NUMBER
EBA471A

LINE	QUANTITY	UOP	CAT. NO.	ITEM NUMBER	UNIT PRICE	AMOUNT
				ADDENDUM NO. 2		
				ADDENDUM ISSUED;		
				1. TO PROVIDE RESPONSES TO VENDORS' QUESTIONS REGARDING THE ABOVE SOLICITATION.		
				2. TO PROVIDE ADDENDUM ACKNOWLEDGMENT. THIS DOCUMENT SHOULD BE SIGNED AND RETURNED WITH YOUR BID. FAILURE TO SIGN AND RETURN MAY RESULT IN THE DISQUALIFICATION OF YOUR BID.		
				END OF ADDENDUM NO. 2		
0001		YR		205-43		
	3			SITE-TO-SITE AND INTERNET CONNECTIVITY		
				***** THIS IS THE END OF RFQ EBA471A ***** TOTAL:

Addendum Number: 2

WVPBS RFQ EBA471A List of Questions

FLOOR PLAN, WSWP-TV

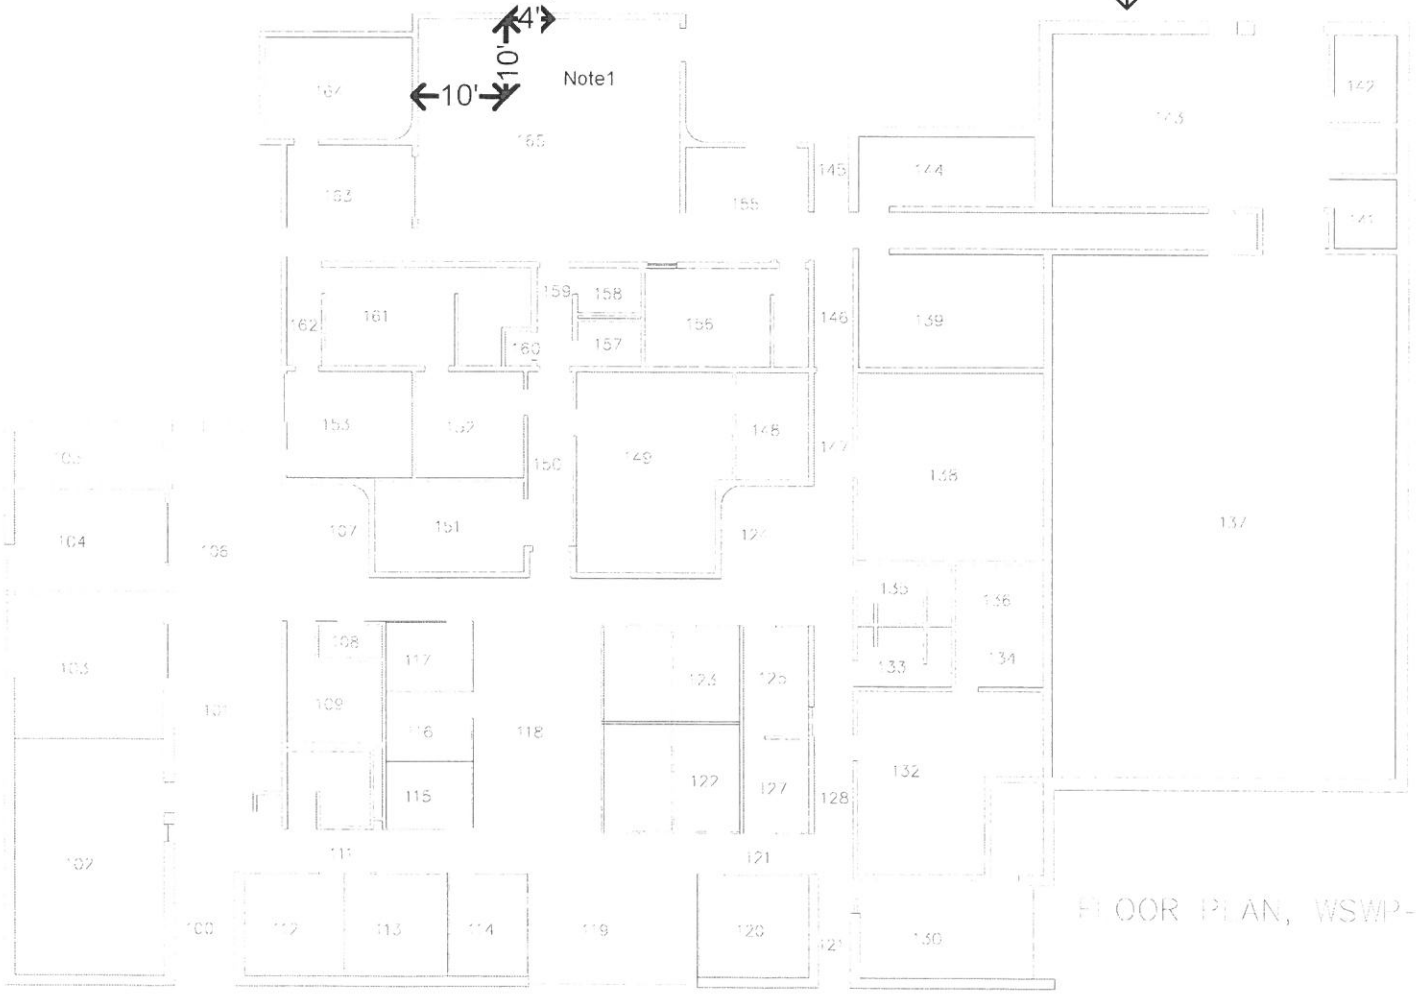
Question 3) Lumos requests a new copy of Beckley Floor Plans this document was changed at the Pre-Bid meeting.

Answer 3) Attached.
